Reference: City of Ottawa comments in the letter dated March 14, 2025 concerning file numbers D02-02-24-0084 & D07-12-24-0177 subject “Feedback Form: Completeness Review (2) Minor Zoning By-law Amendment and Site Plan Control Complex 73, 79 and 83 Ste-Cecile Street”.

Subject: response to the referenced comments following the meeting with C of O staff completed on March 20, 2025.

SUBSURFACE INVESTIGATION REPORT

73, 79 AND 83 STE CECILE ST., OTTAWA, ON, K4A 3N6

Figure 2: Factor of safety of proposed open cut

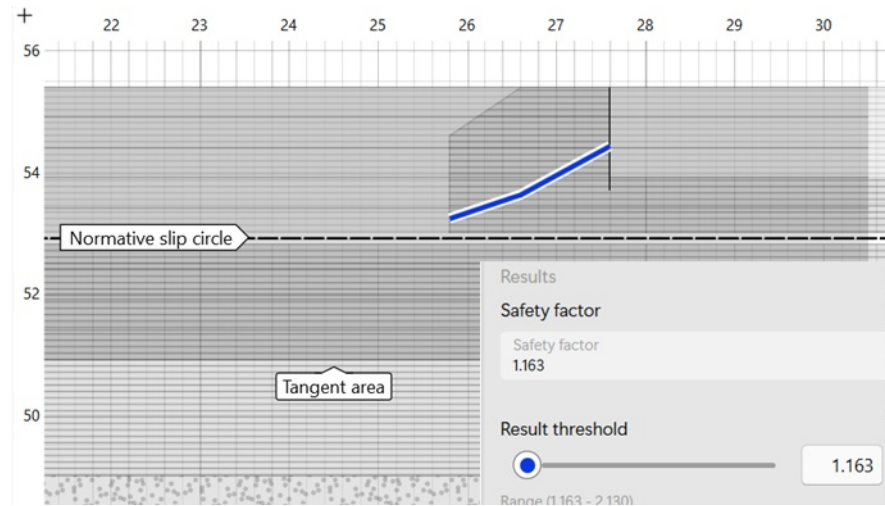
7. i) j) and k)
 - No further action is required once the items above have been addressed.
8. item l. “Although the design of the shoring system is the contractor’s responsibility, the report should still provide mechanical soil properties (unit weight, friction angle, and active/passive earth pressure coefficients) for each soil layer. Additionally, this section should include a more detailed discussion on the site surroundings, setbacks on each side, and anticipated shoring requirements for each boundary.”

- A material properties table has been added to the subsurface materials section. We added an analysis to this section to assess the need of shoring for 2.5 m maximum excavation depths given the materials and the geometry of cuts along the nearest property line.

At this site a preliminary slope stability analysis was completed to examine the need for shoring excavation depths above the water table. The analysis shows that for the geometry shown in fig. 2 in page 15, which applies to the closest property line with 87 Ste. Cecile St., a factor of safety of 1.16 applies to excavations 2.5 m or shallower.

Shoring is required for any excavation deeper than 2.5 m depth.
